**Addendum to the Z-Area
Radiological Performance Assessment**

**WSRC-RP-98-00156
Revision 0**

**ADDENDUM TO THE
RADIOLOGICAL PERFORMANCE ASSESSMENT
FOR THE Z-AREA SALTSTONE DISPOSAL FACILITY
AT THE SAVANNAH RIVER SITE**

**Additional Information Supplied to the
DOE Performance Assessment Peer Review Panel and
DOE Headquarters in Support of Review, 1993-1997**

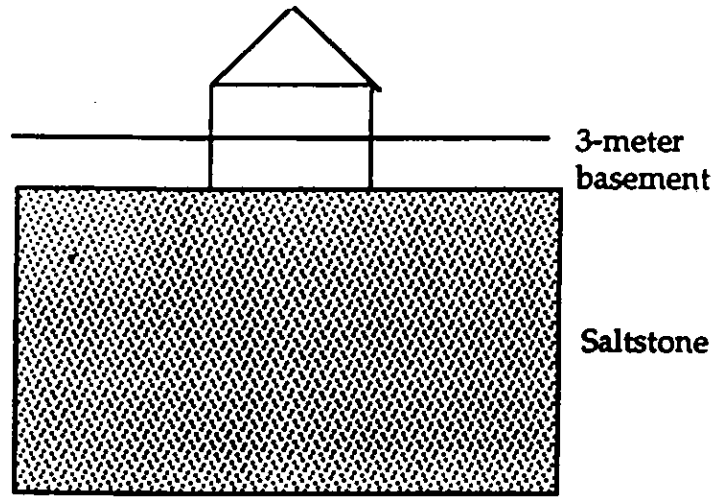
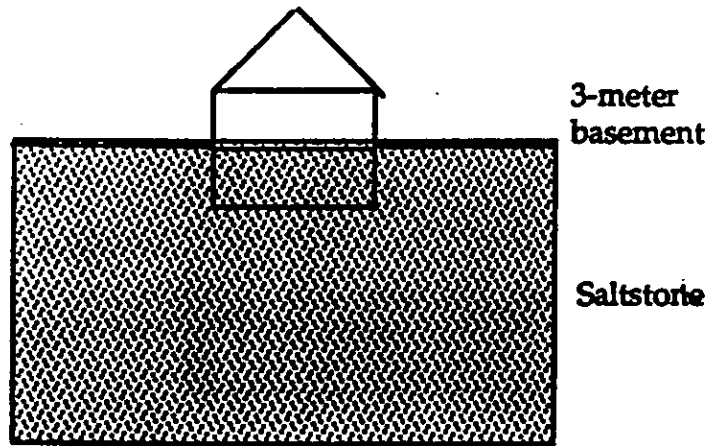
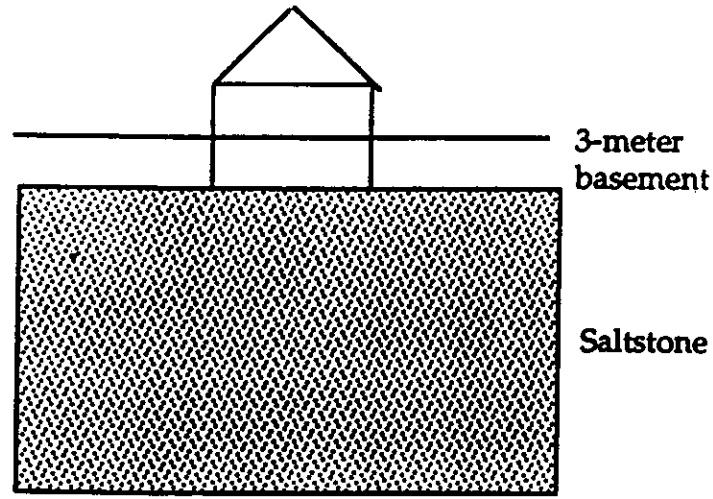
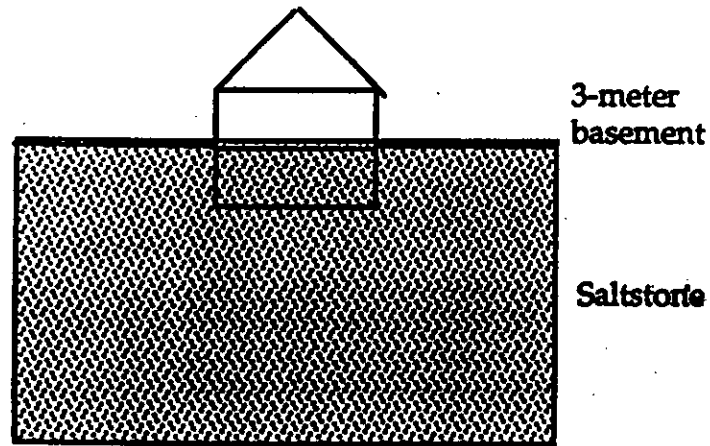
Because the adjusted doses are still relatively close to the 100 mrem/y limit, it would have been useful to do a more realistic analysis of the external radiation doses to resident intruders. For example, it was never really clear what geometry was used to determine the external doses. Specifically, was the basement situated on top of the saltstone units or completed into the degraded units? According to Appendix A,

external exposures were based on radionuclides that are uniformly distributed in a slab of infinite thickness that is made up of soil-equivalent material. A shielding factor of 0.7 is used to reduce exposures because of the protection afforded by floors and walls. Exposures are determined for an individual that is 1 m from the source region. But does that mean an individual living in a basement? Figure 1 depicts two types of basement completions that are possible. The first one (Fig. 1a) has the basement on top of the saltstone, with the barrier gone or degraded. In this case little or no contaminated material has been excavated and mixed with surface soils. In the second case, though, excavated materials are likely to contaminate surface soils. But, as was noted in the text, the saltstone could not support vegetation so clean soils would have to be brought in? Yet would the contaminated materials from the excavation of the foundation be mixed with the imported topsoil? Note that the garden scenario assumes that contaminated soil/saltstone is mixed with uncontaminated topsoil in a ratio of 1:5. Thus, the garden scenario is implicitly tied to some sort of saltstone excavation.

Figure 2. Alternative scenarios of completing houses with concrete slab foundations onto saltstone units with degraded barriers, (a) slab is situated on top of the saltstone and (b) the slab is poured into a shallow foundation penetrating the saltstone.

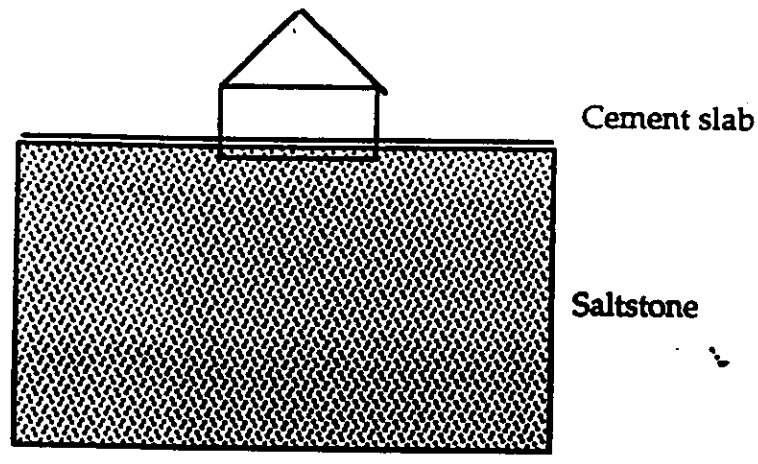
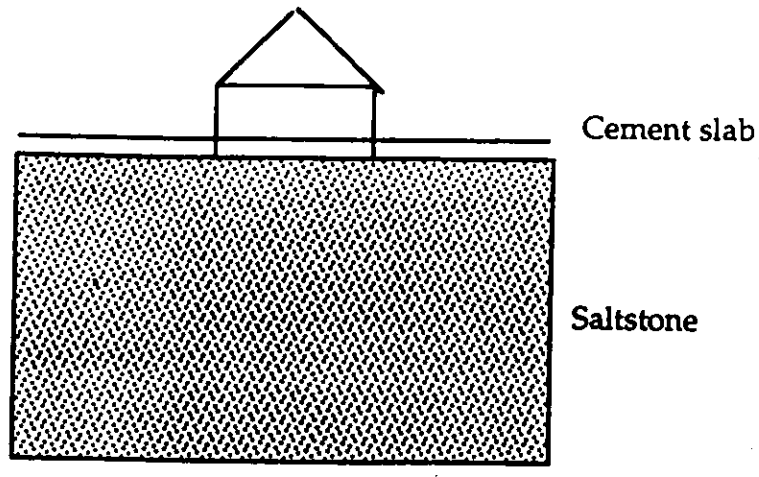
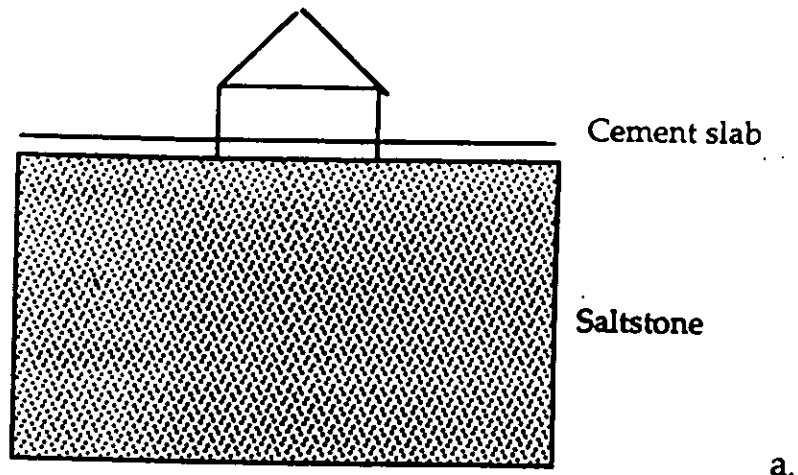
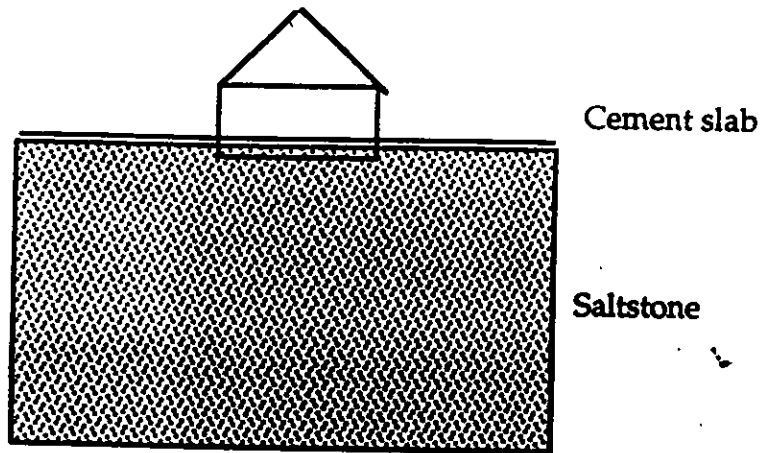
Figure 2 depicts the placement of houses with concrete slabs onto the saltstone units. It would appear that these types of houses come closer to matching the source-receptor geometry that is being assessed in the PA. However, a lot less soil/saltstone is removed with the excavation associated with a concrete slab. For example, the average house in the U.S. has about 150 m² of floor space, and thus with a 3 m basement, 450 m³ of material would be excavated. By comparison, the excavation for a house on a slab might only remove 0.3 m of soil, producing only a tenth as much material. This means that there would be substantially less material to contaminate a home garden or imported topsoil. As a matter of fact, the most prevalent foundations in the South are concrete slabs and perimeter foundations (crawl space). Only about 20% of the houses have full or partial basements (see Fig. 3). Thus, a more realistic assessment would focus on the external radiation exposures for individuals living in houses that are more representative of those build in the South.
